A63 Castle Street Improvement, Hull

Scheme Number: TR010016

ENVIRONMENTAL STATEMENT VOLUME 1 ADDENDUM 2

Environmental Statement Volume 1 Addendum 2 Yorkshire Water Drainage Network

Figure 1: Location of previous proposed long rising main route and outfalls and new proposed short rising route

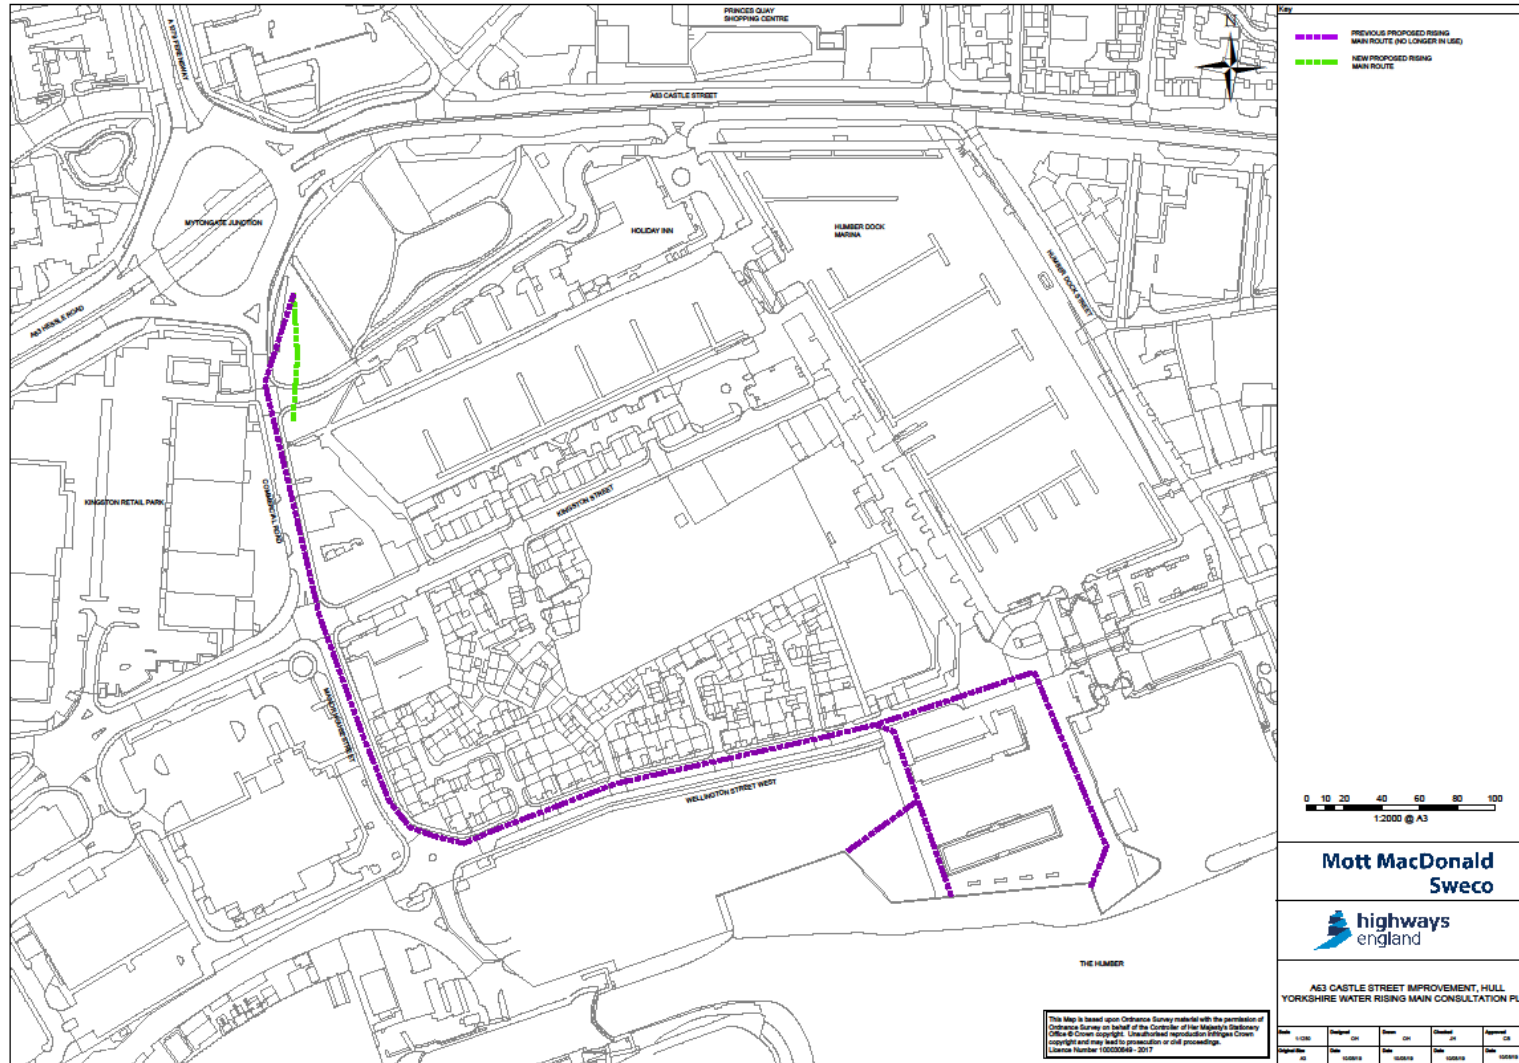
1.2.2 The alternative drainage option to usage of the YW network was to direct the discharge of surface water from the proposed underpass at Mytongate Junction, via a new long rising main to one of three outfall locations into the Humber as shown on Figure 1. The use of existing rock armour at the proposed outfall locations was proposed to prevent the discharge from scouring the river bed and creating silt plumes that could be detrimental to estuarine habitats and species.

- The long rising main route to the outfall - down Commercial Road, Manor House Street and Wellington Street West - can be removed
- A short rising main route from the pumping station across the Holiday Inn access road to a proposed manhole in the land adjacent to Commercial Road – is now required as shown on Figure 1.
- All three proposed outfall locations – can be removed

- 3.1.1 Taking into account the above, it is concluded that there are no significant implications to the findings of the ES from the removal of the long rising main route and outfall locations from the Scheme and the inclusion instead of the use of the YW drainage network and a short rising main from the pumping station across the Holiday Inn access road to a proposed manhole in the land adjacent to Commercial Road.
